KERR-McGEE CHEMICAL CORPORATION

Re: Kerr-McGee Chemical Corporation
Henderson, Nevada
EPA ID No. NVD 008290330
Landfill Closure/Post-Closure Plan

CLOSURE/POST-CLOSURE PLAN

Deficiencies and Required
Improvements to Closure/Post-Closure
Plans and Cost Estimates

KERR MCGEE
WASTE CELL CAP PLAN & DETAILS

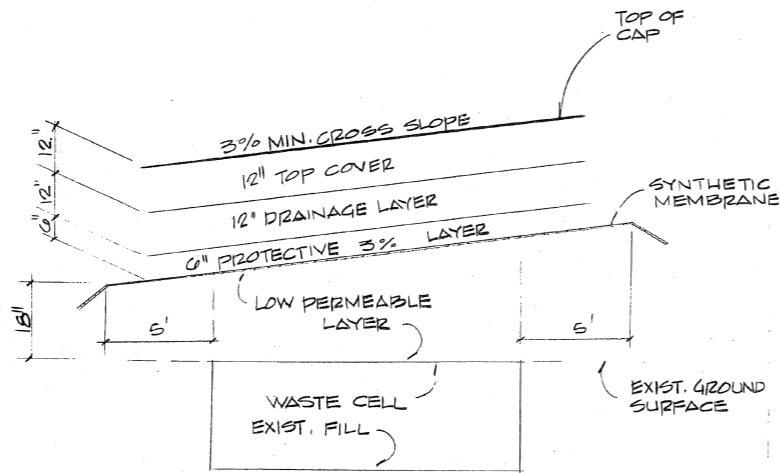
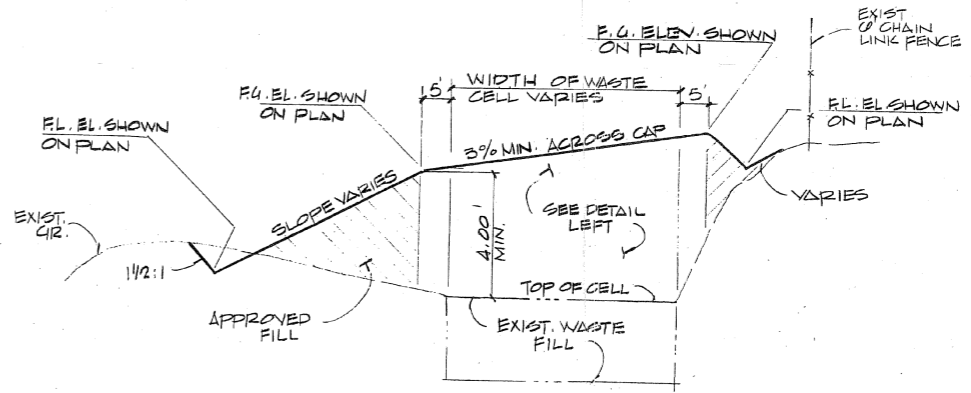
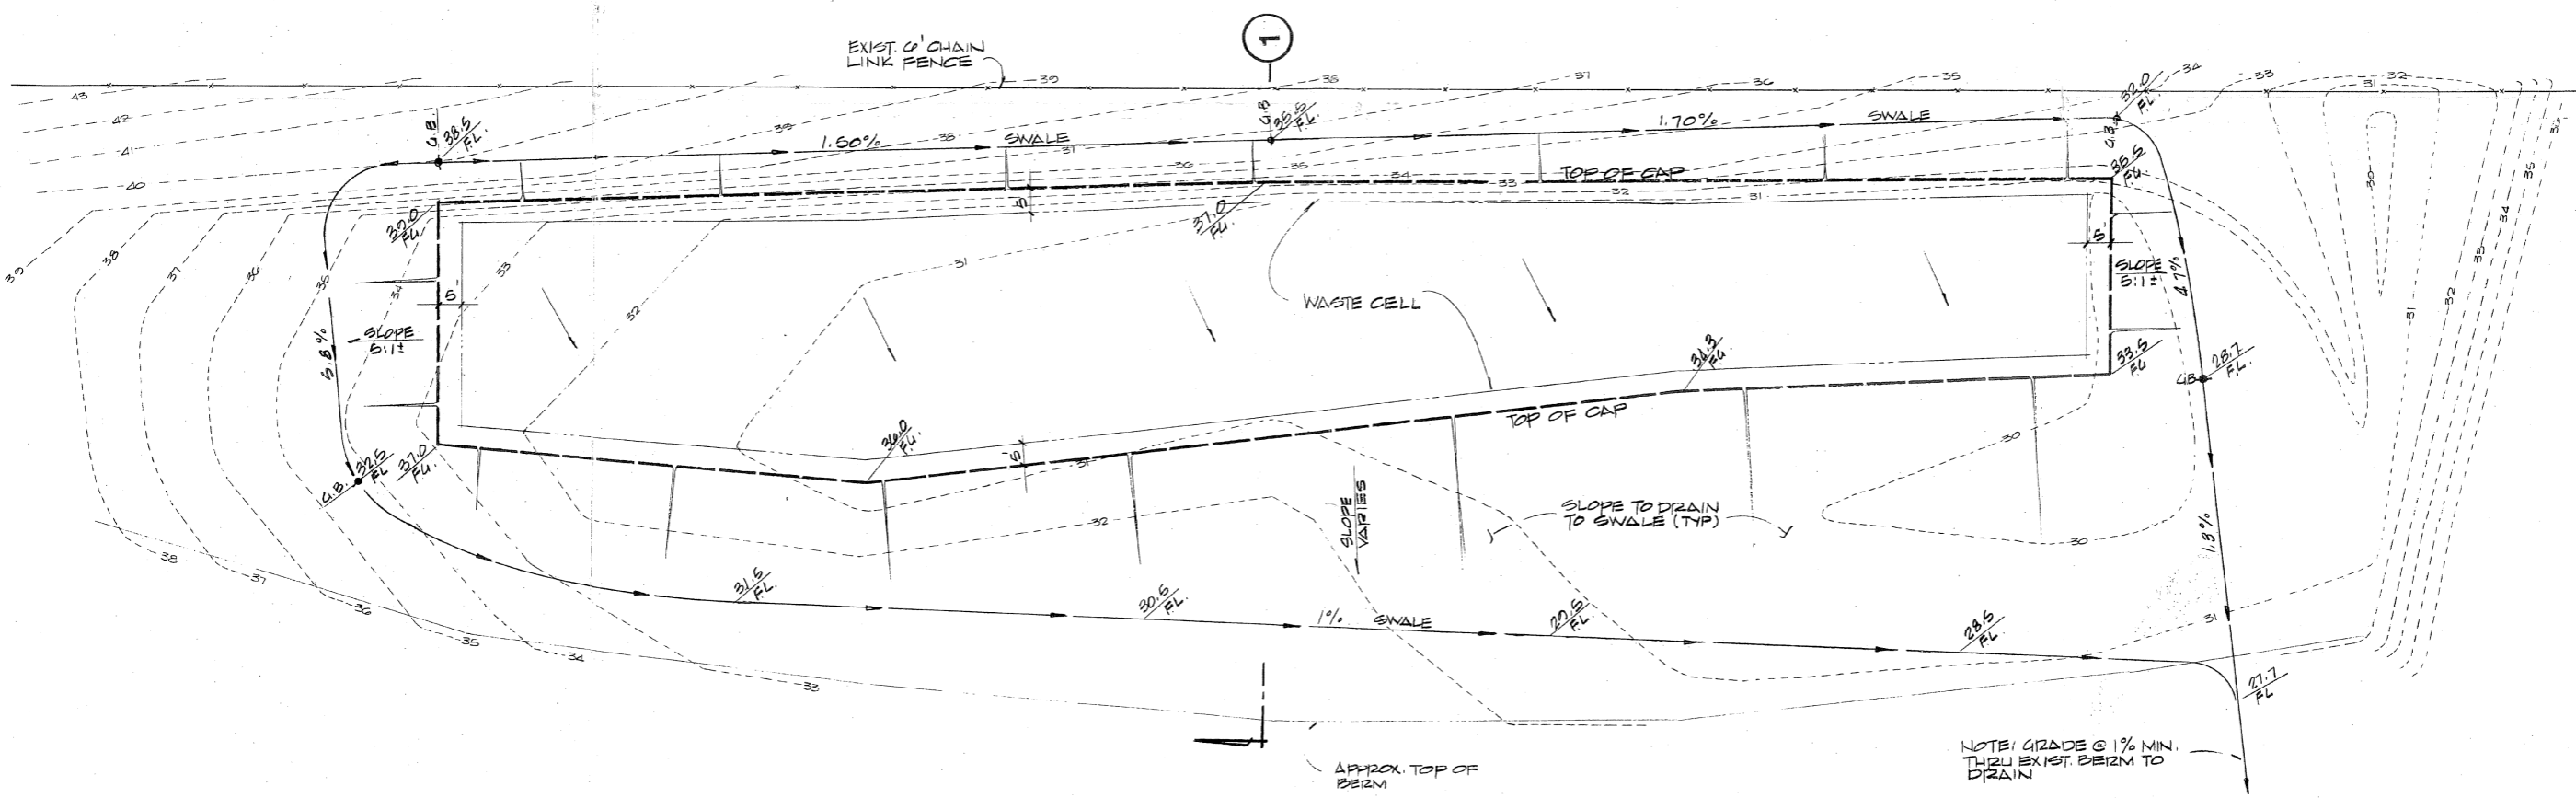
REVISIONS	REVISED CAP THICK- NESS PER LEZZ.
DATE	INC LEE
